## HISTORIC AND DESIGN REVIEW COMMISSION

February 06, 2019

**HDRC CASE NO:** 2019-036  
**ADDRESS:** 215 NELSON AVE  
**LEGAL DESCRIPTION:** NCB 3888 BLK 4 LOT 16  
**ZONING:** RM-4, H  
**CITY COUNCIL DIST.:** 2  
**DISTRICT:** Knob Hill Historic District  
**APPLICANT:** Jordan Mengele/Sotex Property Brothers LLC  
**OWNER:** Jordan Mengele/Sotex Property Brothers LLC  
**TYPE OF WORK:** Window replacement  
**APPLICATION RECEIVED:** January 10, 2019  
**60-DAY REVIEW:** March 09, 2019  
**REQUEST:**

The applicant is requesting a Certificate of Appropriateness for approval to install new vinyl windows to replace existing, wood windows.

Left  
Side

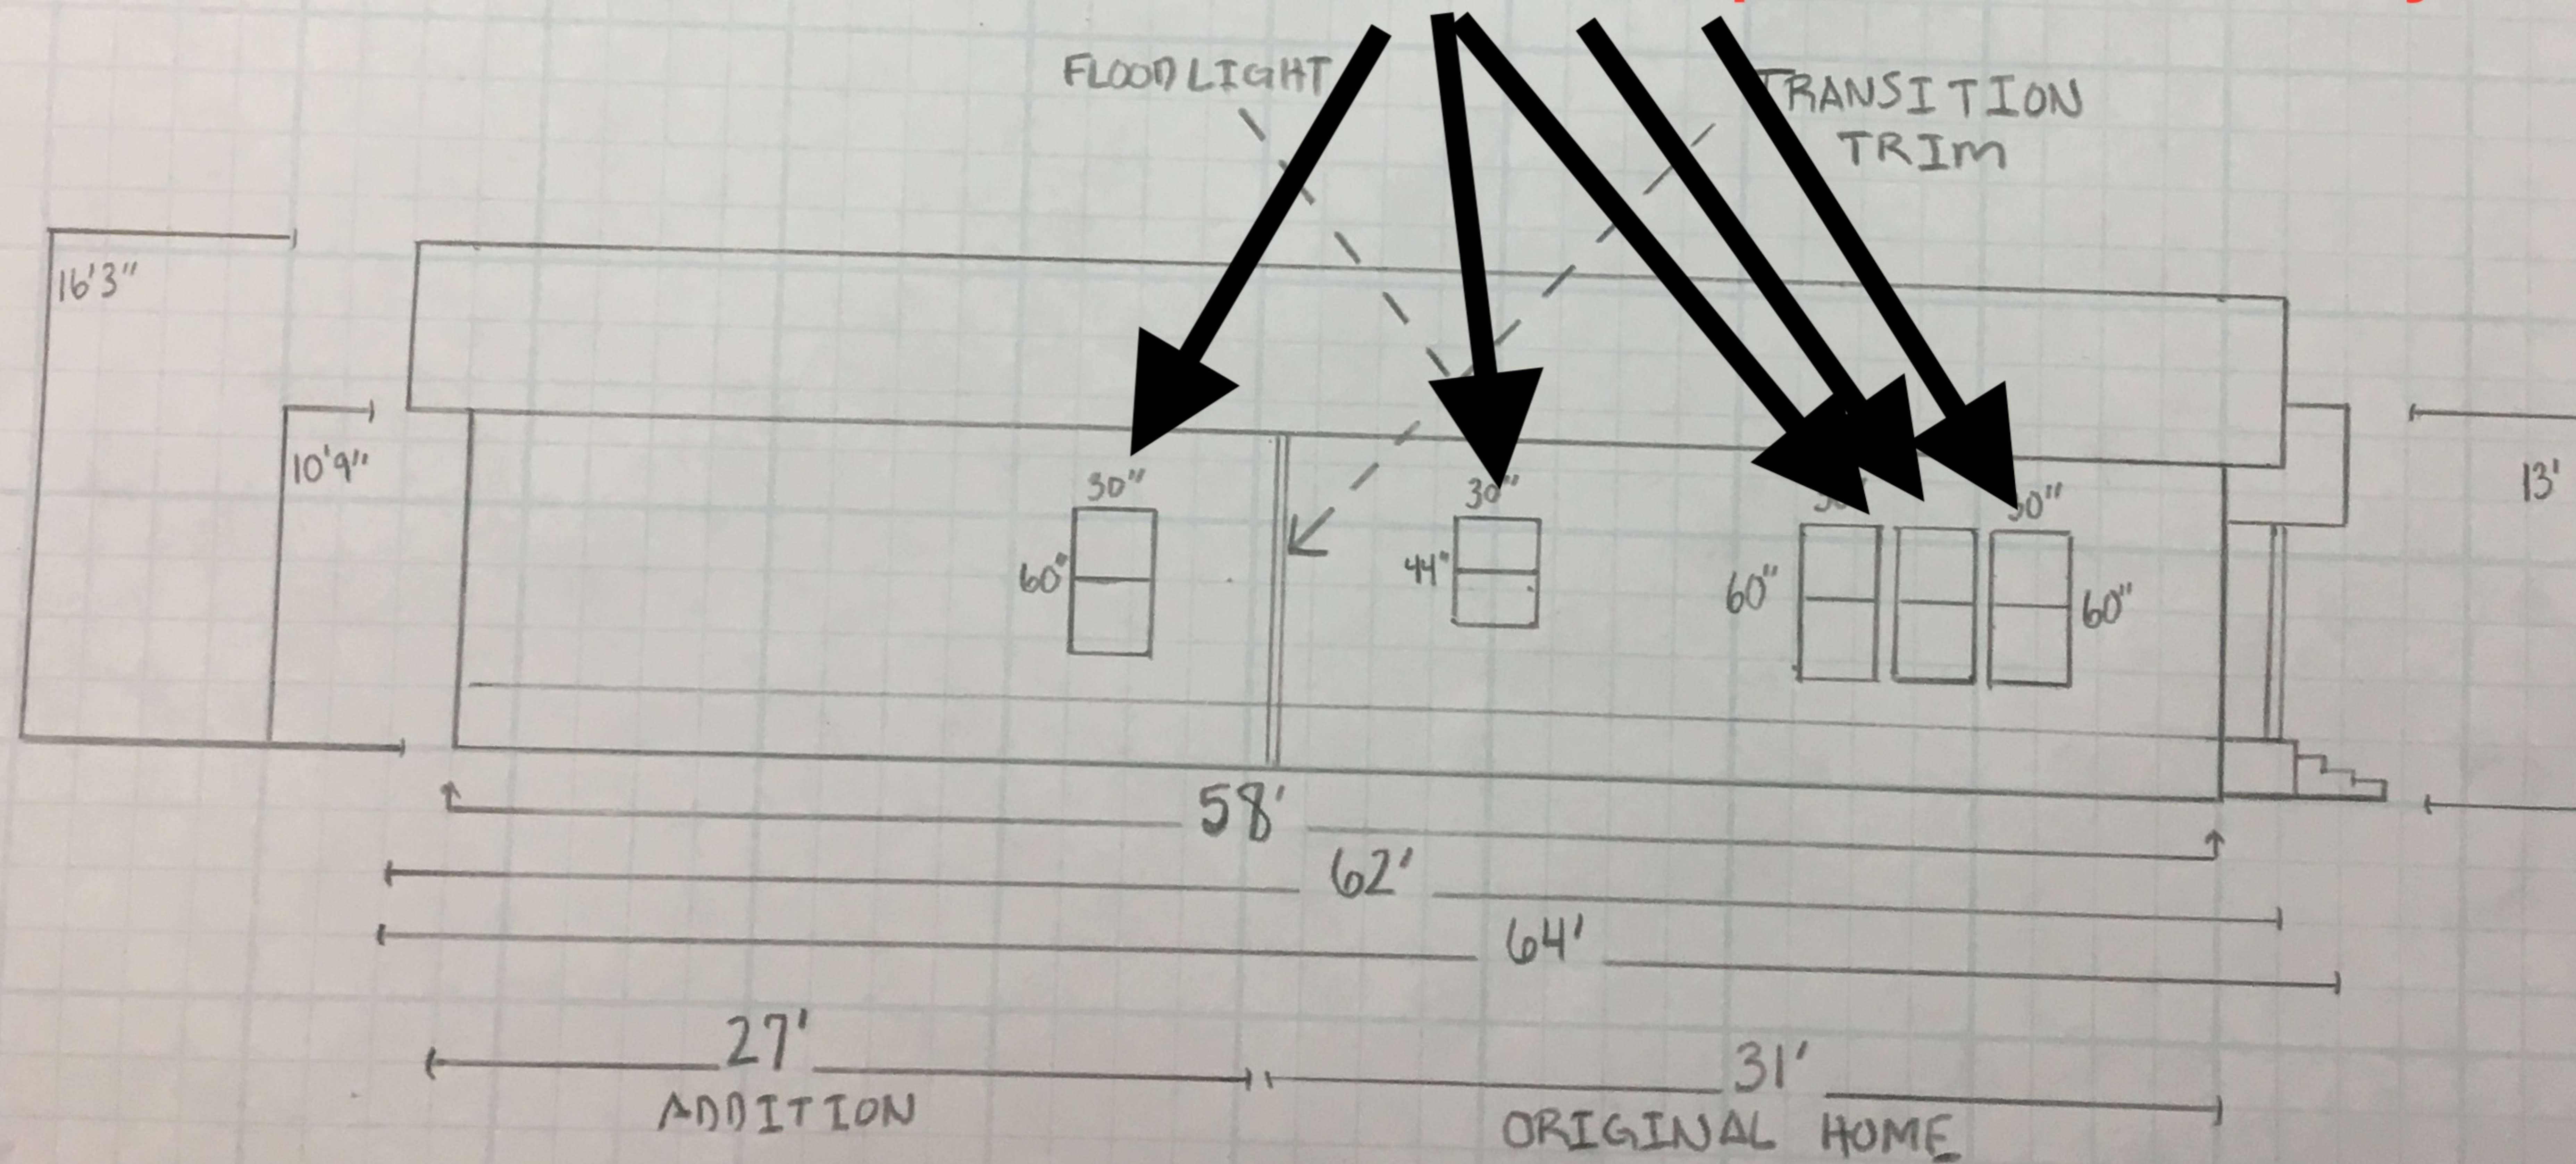
Stolen wood window to replace with vinyl

Staff does not recommend approval based on findings a through d. Staff recommends in-kind replacement of the wood sash windows to match the original size, configuration, location, materials, and the standard stipulations. If in-kind replacement is approved, the applicant must submit updated window specifications to staff prior to the issuance of a Certificate of Appropriateness.

Right  
Side

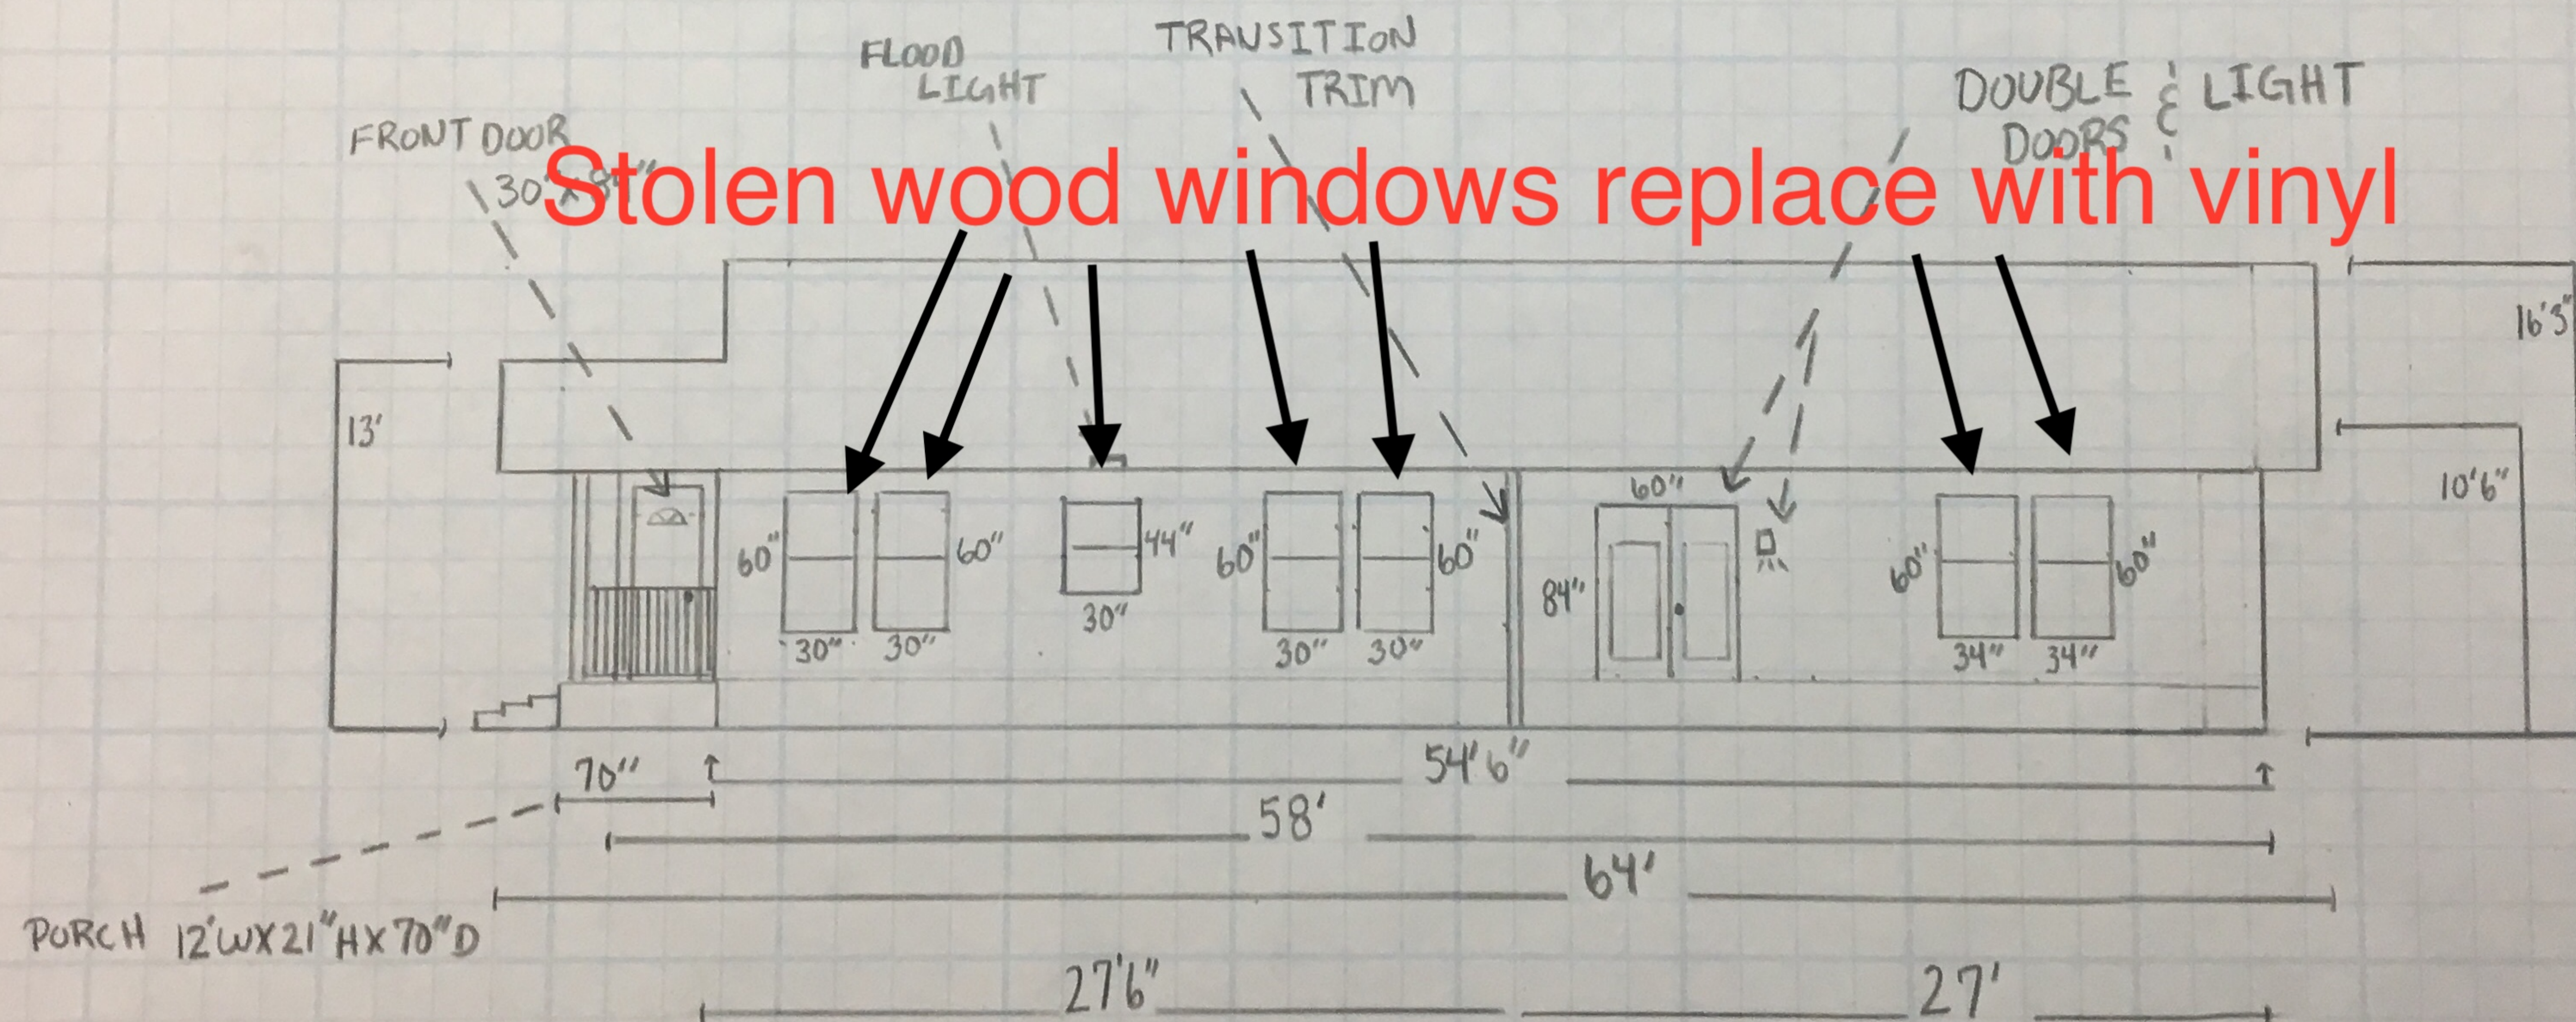
Stolen wood windows replace with vinyl
